Riverton Harbour Subcommittee Agenda OPEN

Riverton Wharves Maintenance Update

**2018 RIVERTON MARINE STRUCTURES
INSPECTION REPORT**

November 2018

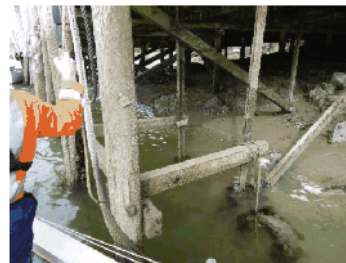
Piles	All except 2 of the HW piles are satisfactory and all railway iron piles at upstream end are also satisfactory.		
Additional info and comments	Shed: 2.8 x 2.6m. Has had an internal fire with walls and roof framing at one end badly damaged. Remaining walls, roof and floor appear sound.		
Previous Recommendations	<p>General nailing of deck planking and replacement of the two split, wasted and broken piles to be completed within 6-12 months.</p> <p>Refer photo over for location. Ensure when replacing piles all bracing is reinstated.</p>		
2018 Inspection	3 Piles have been replaced and fixings have been replaced as required.

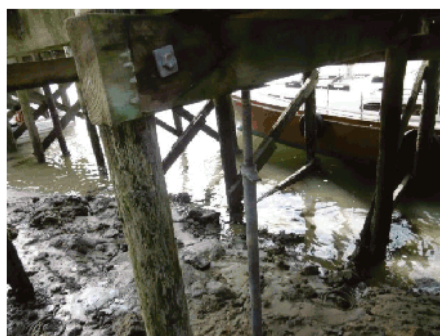
Piles	6 pairs on wharf plus 3 pairs on approach all ok		
Additional info and comments	Handrail section on wharf in poor condition. This will require upgrading if it is to remain		
Previous Recommendations	Replace deck planks on approach and reinstate bracing on two upstream bents. This may be as simple as lifting the brace at the bottom connection and fastening with new 20dia galv bolts. Using larger diameter bolts and 50x50 min washers decreases the wood fibre crushing experienced with smaller diameter bolts and washers and increases durability of connection		
2018 Inspection	Bracing has been addressed on main wharf and approach timbers are now satisfactory.

L22

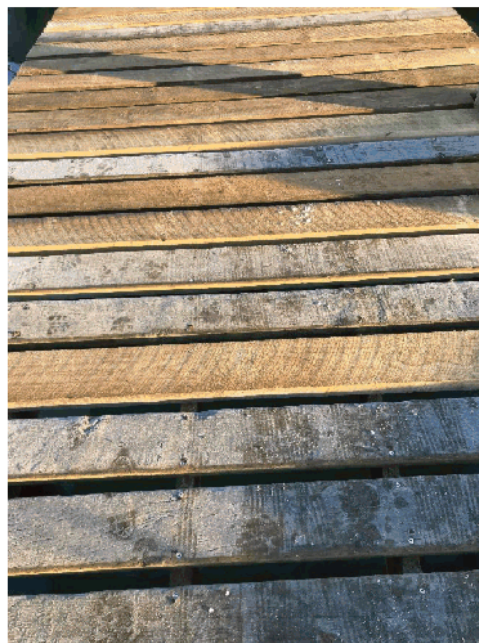
Piles	All seven pairs of piles are sound		
Previous Recommendations	<p>Replace deck planks and general deck fastening.</p> <p>Deck beam at bents 6-7 to be replaced as soon as practical but within 6 months.</p> <p>Bolts in all headstocks need to be inspected and if exposed and seen to have advanced corrosion or noticeable loss of section they need to be replaced. Where fixing looks ok paint any exposed steel with 'Flintcoat' or similar bituminous paint.</p> <p>Bottom connections on all cross bracing at every bent have failed. Where failure is from bolt or degradation of existing brace is minor, brace can be lifted to slightly flatter angle and new fastening installed. Where the degradation is significant, the brace should be replaced in the short term of 6-12 months.</p>		
2018 Inspection	<p>Deck planking and fastenings have been replaced and are good. Selected deck beams have also been replaced where required. Additional bolt fastenings have been added where the existing were poor. All bracing and associated fastenings have been replaced.</p> <p>Recommend applying 'Flintcoat' or similar bituminous coating to all fastenings to ensure required durability is achieved.</p>

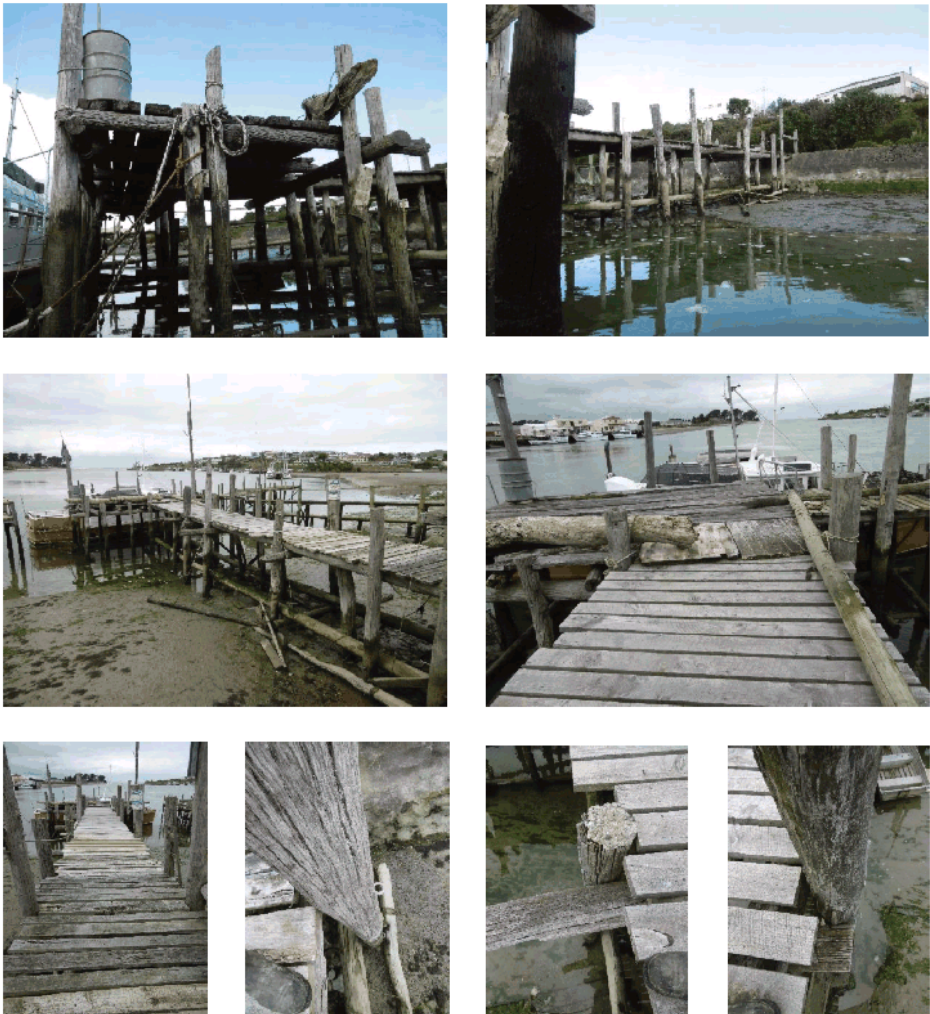
It is recommended that the owners be required to present a programme for repair or replacement within 2 months. The plan to be subject to approval by SDC with the intention to restore the structure to an acceptable level within 6 months of approval being granted, at which time a further inspection will be made.

The continued validity of the licence to occupy sea bed to be conditional upon compliance with the above

T-Wharf

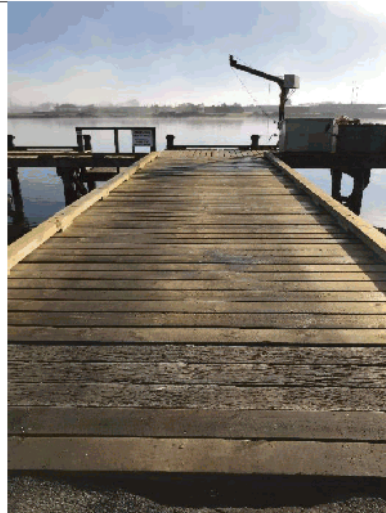
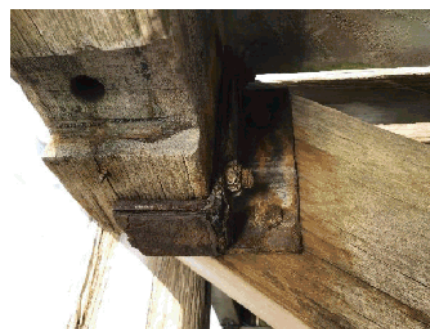
Decking has been replaced as required and is generally well secured. Some decking needs to be addressed on the lower boarding platform.

Badly corroded steel brackets and fastenings require immediate attention.
